To: INCITS T10 Committee  
 From: Paul Entzel, Quantum  
 Date: 12 September 2006  
 Document: T10/06-236r1  
 Subject: FCP-4 Fix race condition between REC ACC and FCP\_XFER\_RDY

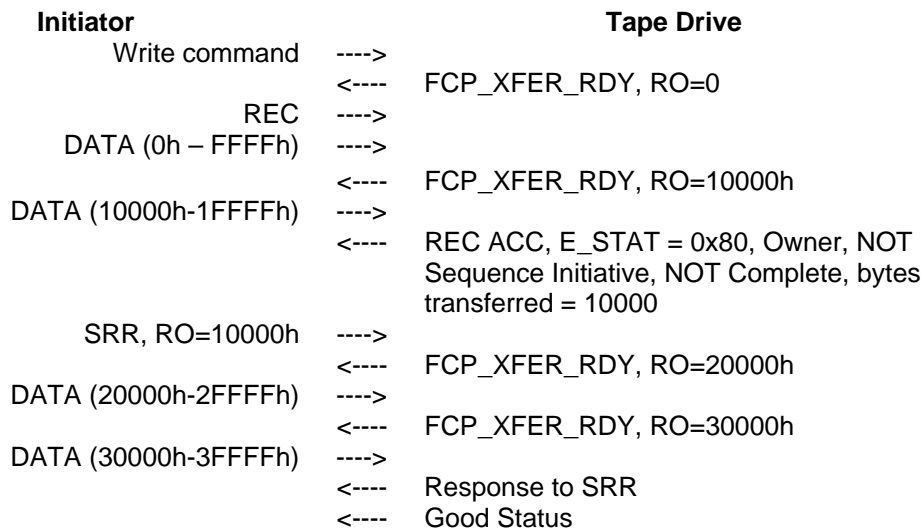
Recently, we have experienced a problem that is similar to this in a Fibre Channel tape drive that was performing extended recovery operations on the medium during a write operation. The buffer filled and a new write command was sent when there was no room in the buffer for the data associated with the command. The HBA polled with an REC every few seconds until at last there was room in the buffer. The REC and the FCP\_XFER\_RDY were timed so closely that they may have actually passed each other in the Fibre. Here is a ladder diagram of the condition:

This isn't exactly covered by the text in table C.5, since the FCP\_XFER\_RDY was received by the initiator port before the ACC for the REC, not after. The HBA has not violated the standard since there is no

requirement in the normative part of the standard governing this case. However, the problem could have been avoided had the HBA ignored the REC ACC payload and not performed a retry based on the fact that it had received traffic for the exchange in question since it had sent the REC. This proposal will attempt to correct this condition by adding requirements within the normative clauses in FCP-4 to cover the case already described in table C.5 and expanding it to cover the case described by the ladder diagram above.

If the ACC for an REC indicates that an FCP\_XFER\_RDY IU was sent by the target FCP\_Port (i.e., by indicating that the initiator FCP\_Port holds Sequence Initiative, that all bytes were not transferred, and that the Exchange is not complete), but not received by the initiator FCP\_Port, the initiator FCP\_Port shall issue an SRR in a new Exchange to request retransmission of the FCP\_XFER\_RDY IU. [To avoid race conditions between the ACC for an REC and an FCP\\_XFER\\_RDY IU, the initiator FCP\\_Port should wait REC\\_TOV after receiving the ACC for an REC before sending an SRR to recover for a lost FCP\\_XFER\\_RDY IU. If the initiator FCP\\_Port receives an FCP\\_XFER\\_RDY IU for an exchange after sending an REC or within REC\\_TOV time after receiving an ACC for an REC, it shall continue normal processing of the FCP I/O operation for that exchange and ignore the contents of the ACC.](#)
